UNITED STATES ENVIRONMENTAL PROTECTION AGENCY

Re: *Conditional Approval of Revised Corrective Measure Proposal*
Tecumseh Products Company, 100 East Patterson, Tecumseh, Michigan 49286
EPA ID#: MID005049440
AOC RCRA-05-2010-0012

The US EPA has completed a review of the *Revised Corrective Measures Proposal* (CMP), dated March 6, 2017 that TRC prepared on behalf of Tecumseh Products Company (TPC). Based on that review and follow-up discussions with TPC, and in consultation with the MDEQ's Remediation Advisory Team, US EPA conditionally approves the CMP.

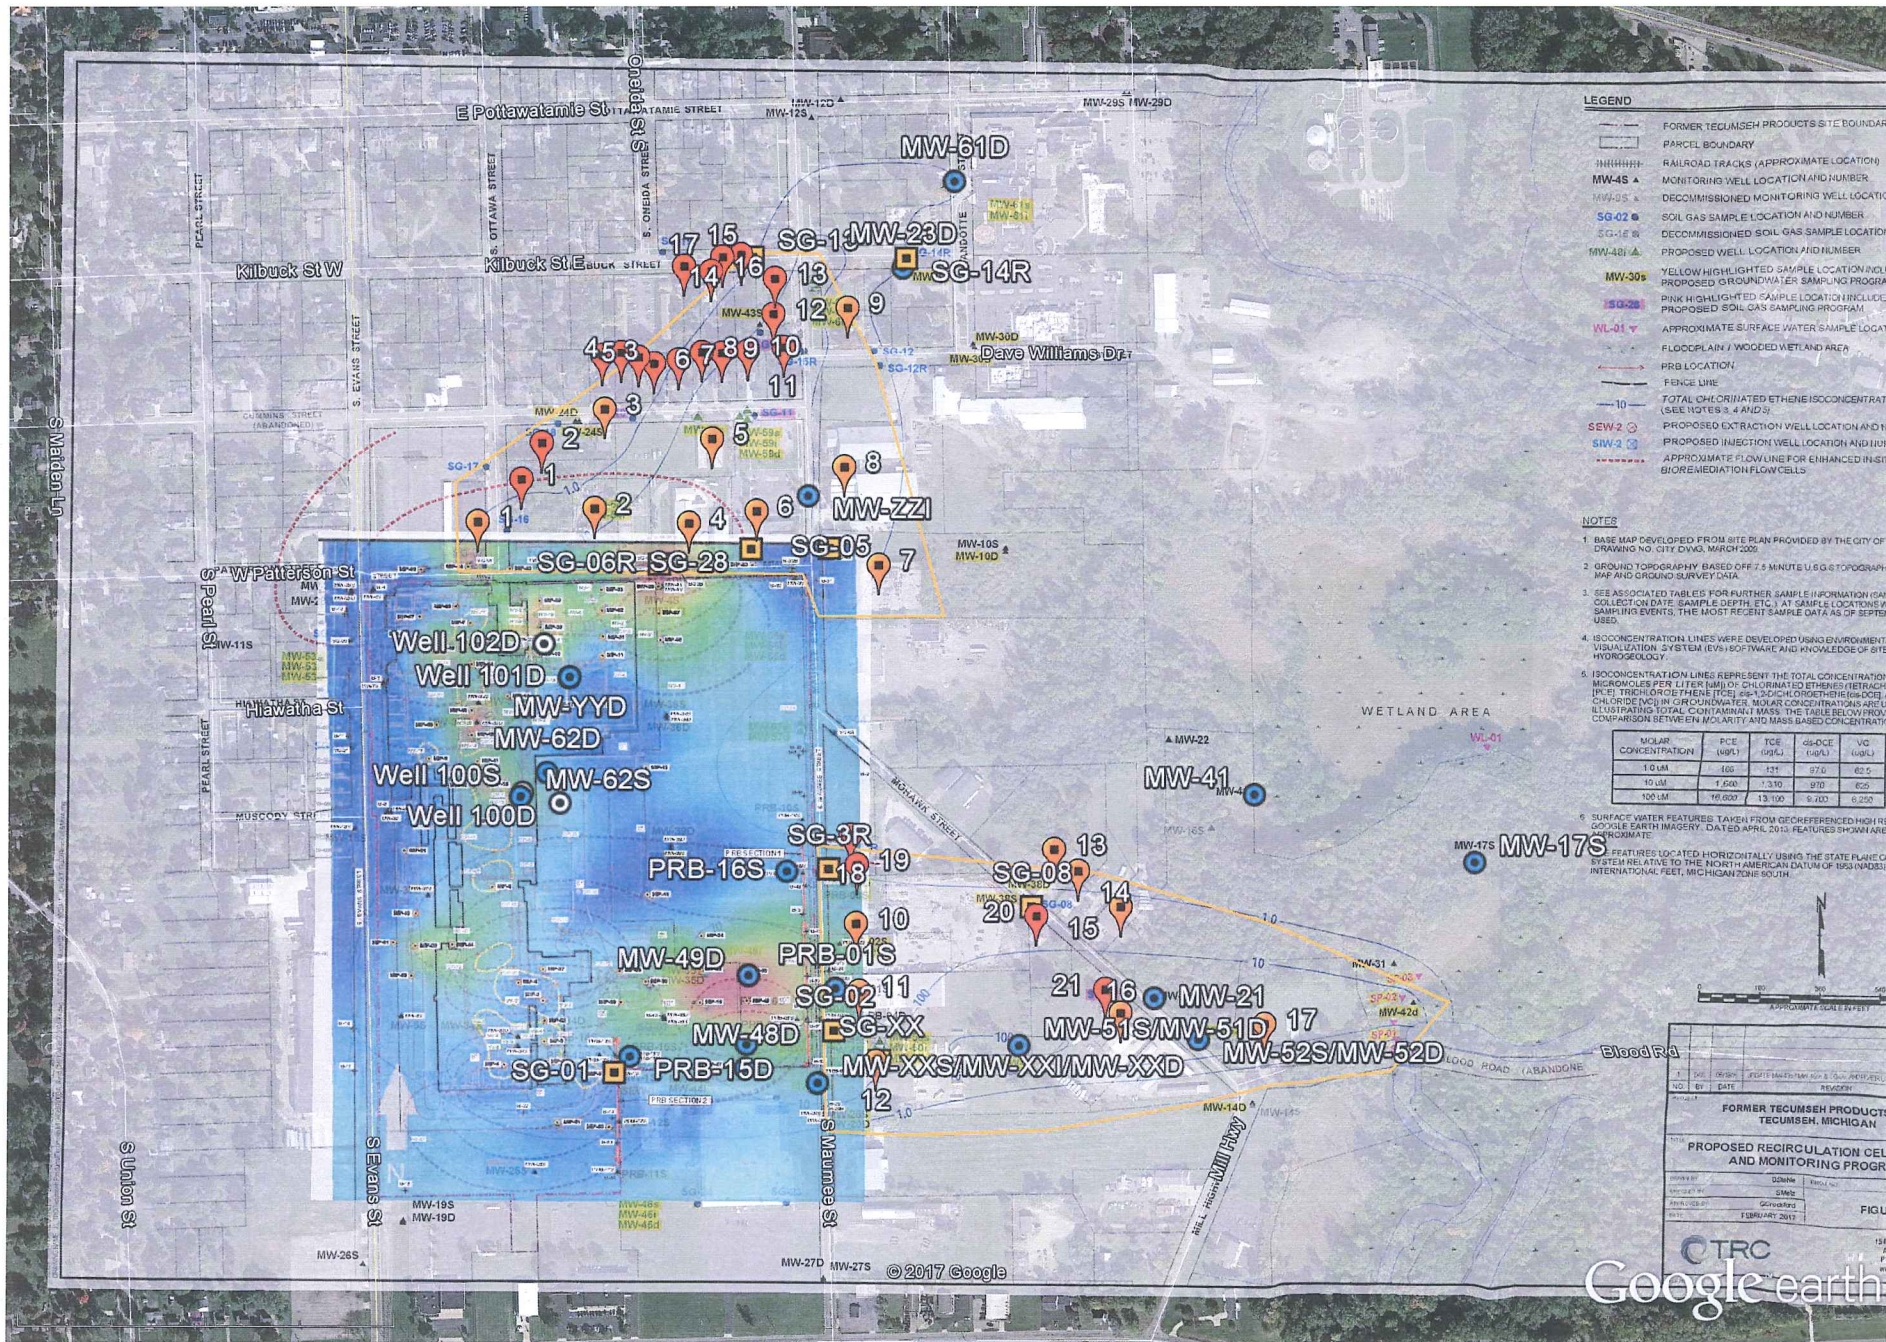
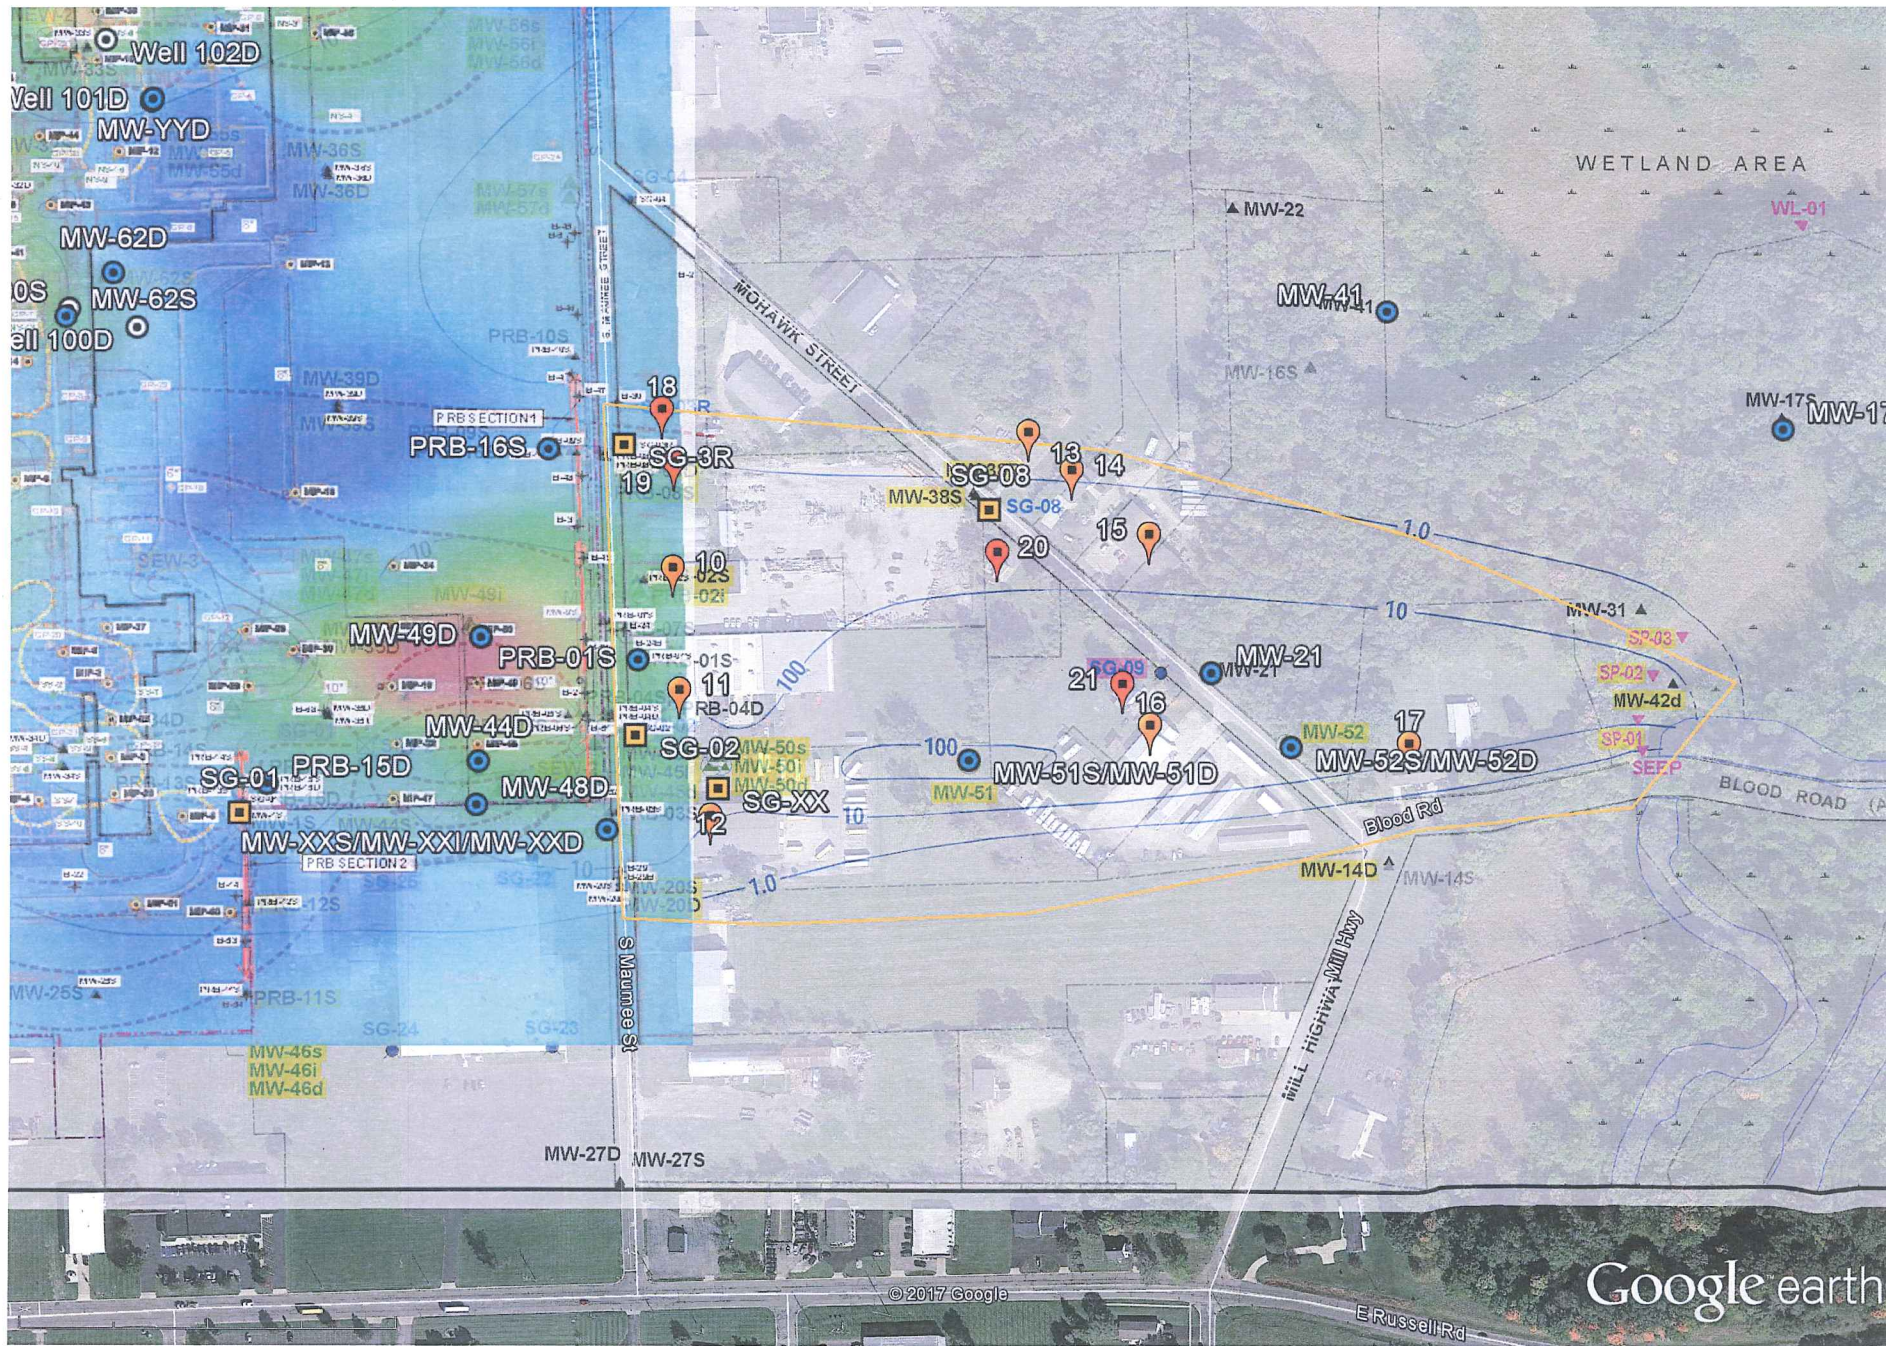
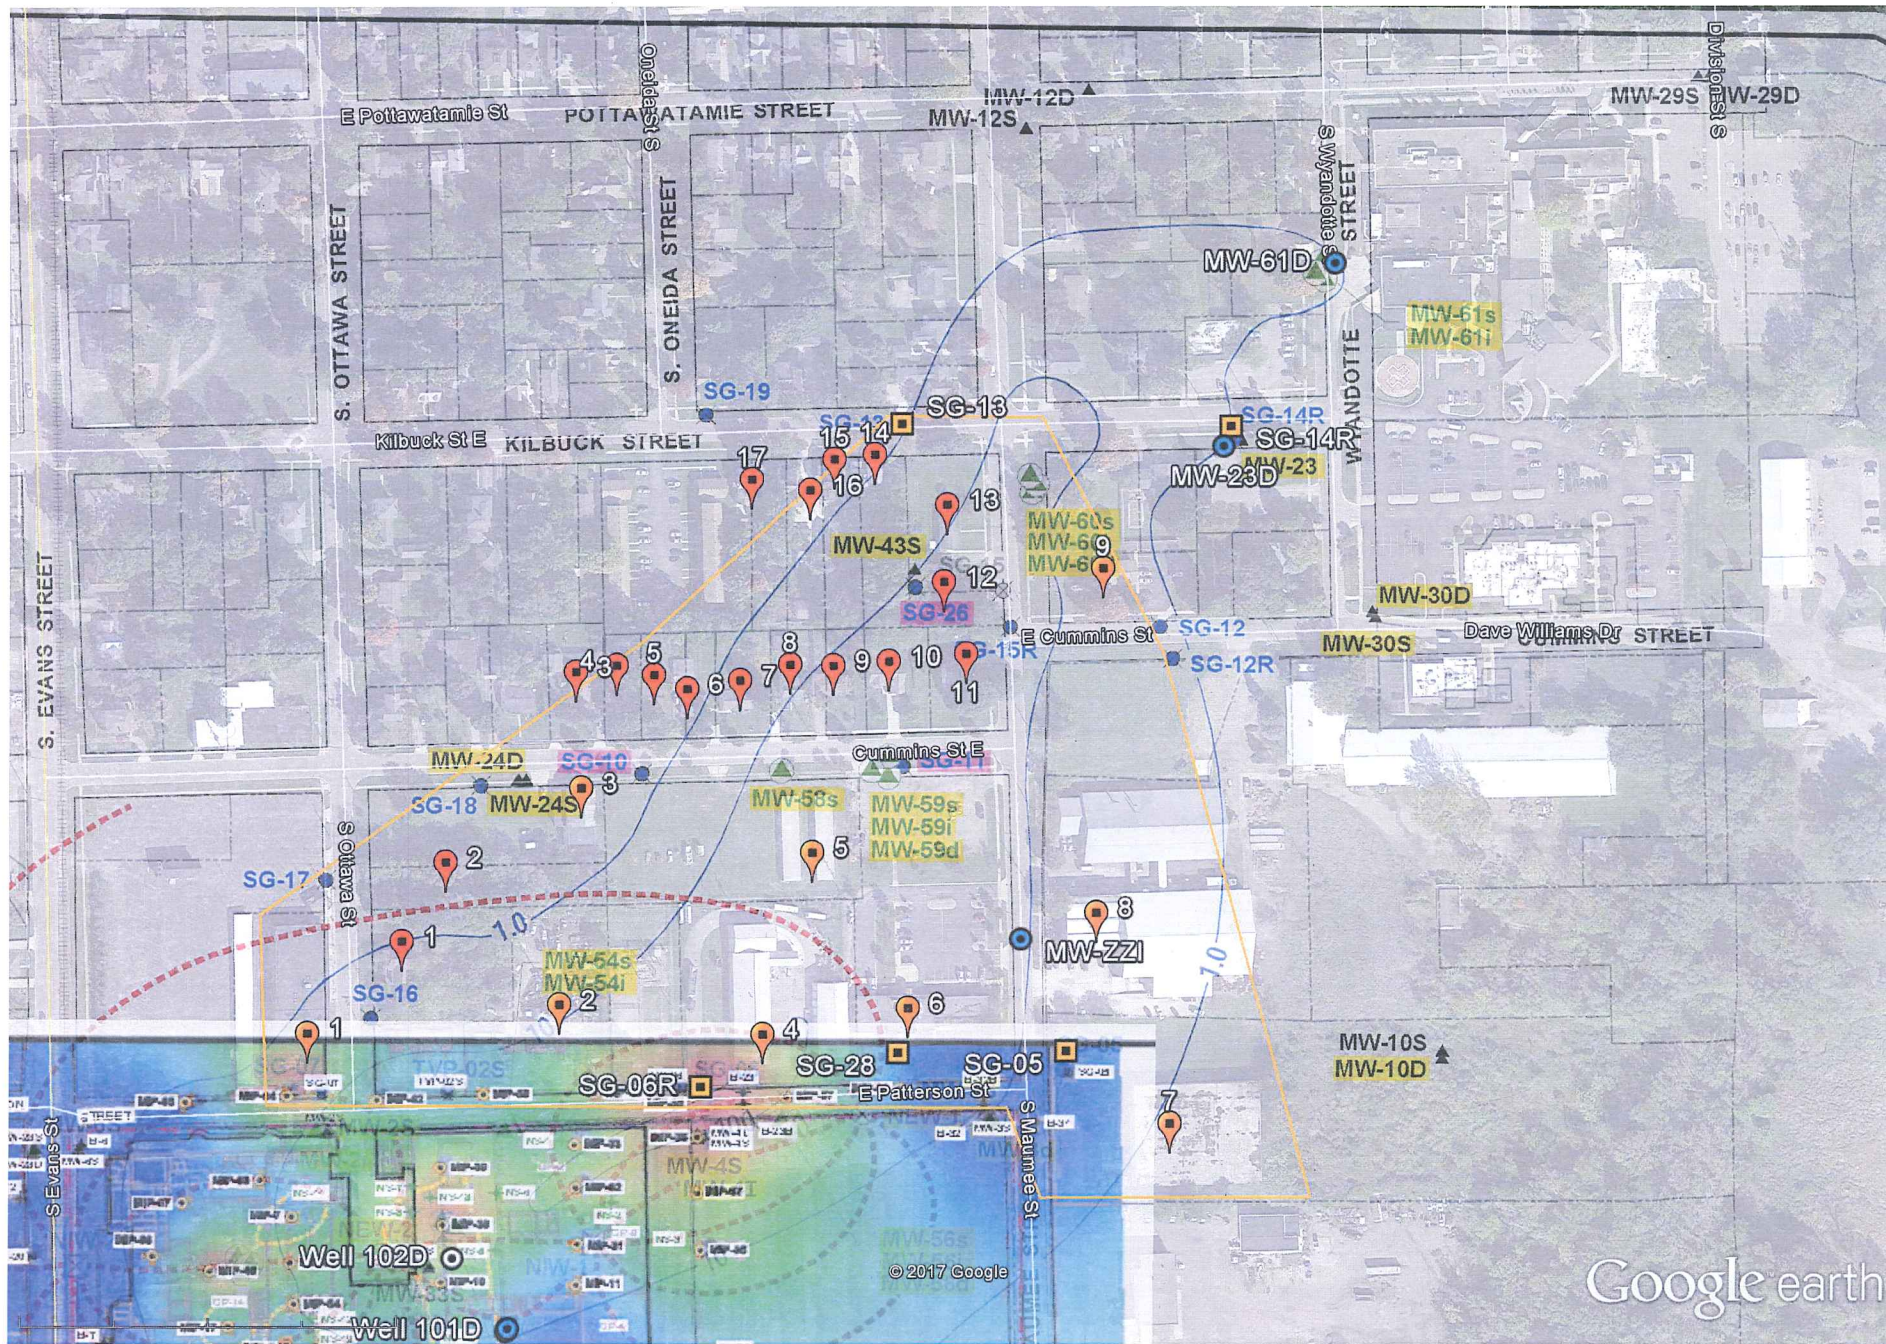
After reviewing the modifications in the revised 3/6/17 CMP, your proposed locations for groundwater monitoring are much closer to what I had envisioned. In addition to those locations proposed in the 3/6/2017 CMP, EPA requests the inclusion of performance groundwater monitoring at existing wells PRB-01S, PRB-15D, PRB-16S, MW-17S, MW-21, and MW-41, and has identified the need for monitoring at additional depths at locations proposed in the 3/6/2017 CMP to include MW-44D, MW-48D, MW-49D, MW-51 (include both shallow and deep intervals), MW-52 (include both shallow and deep intervals), MW-61D, MW-62 (include both shallow and deep intervals closer to source), MW-XX (shallow, intermediate and deep intervals at SB-80), MW-YY (deep interval, source areas south of MW-33S, installed east of source), and MW-ZZI (intermediate depth along Maumee, between Cummins and Patterson. These are shown on the attached Modifications.kmz file, compared with the locations proposed in the 3/6/16 CMP (New Proposed Monitoring.kmz).

In addition to those locations proposed in the 3/6/2017 CMP, EPA requests the inclusion of performance soil gas monitoring at existing locations SG-01, SG-02, SG-03R, SG-05, SG-08, SG-13, SG-14R, SG-28. EPA proposes the installation of a new soil gas location (or collocated vapor pin/indoor air location) at SG-XX, at the property where MW-50 is proposed. EPA also requests the potential reinstallation of SG-06R, given that the soil gas results appear inconsistent with groundwater data from this area, to determine if the existing location is isolated from subsurface contamination by a subsurface anomaly.
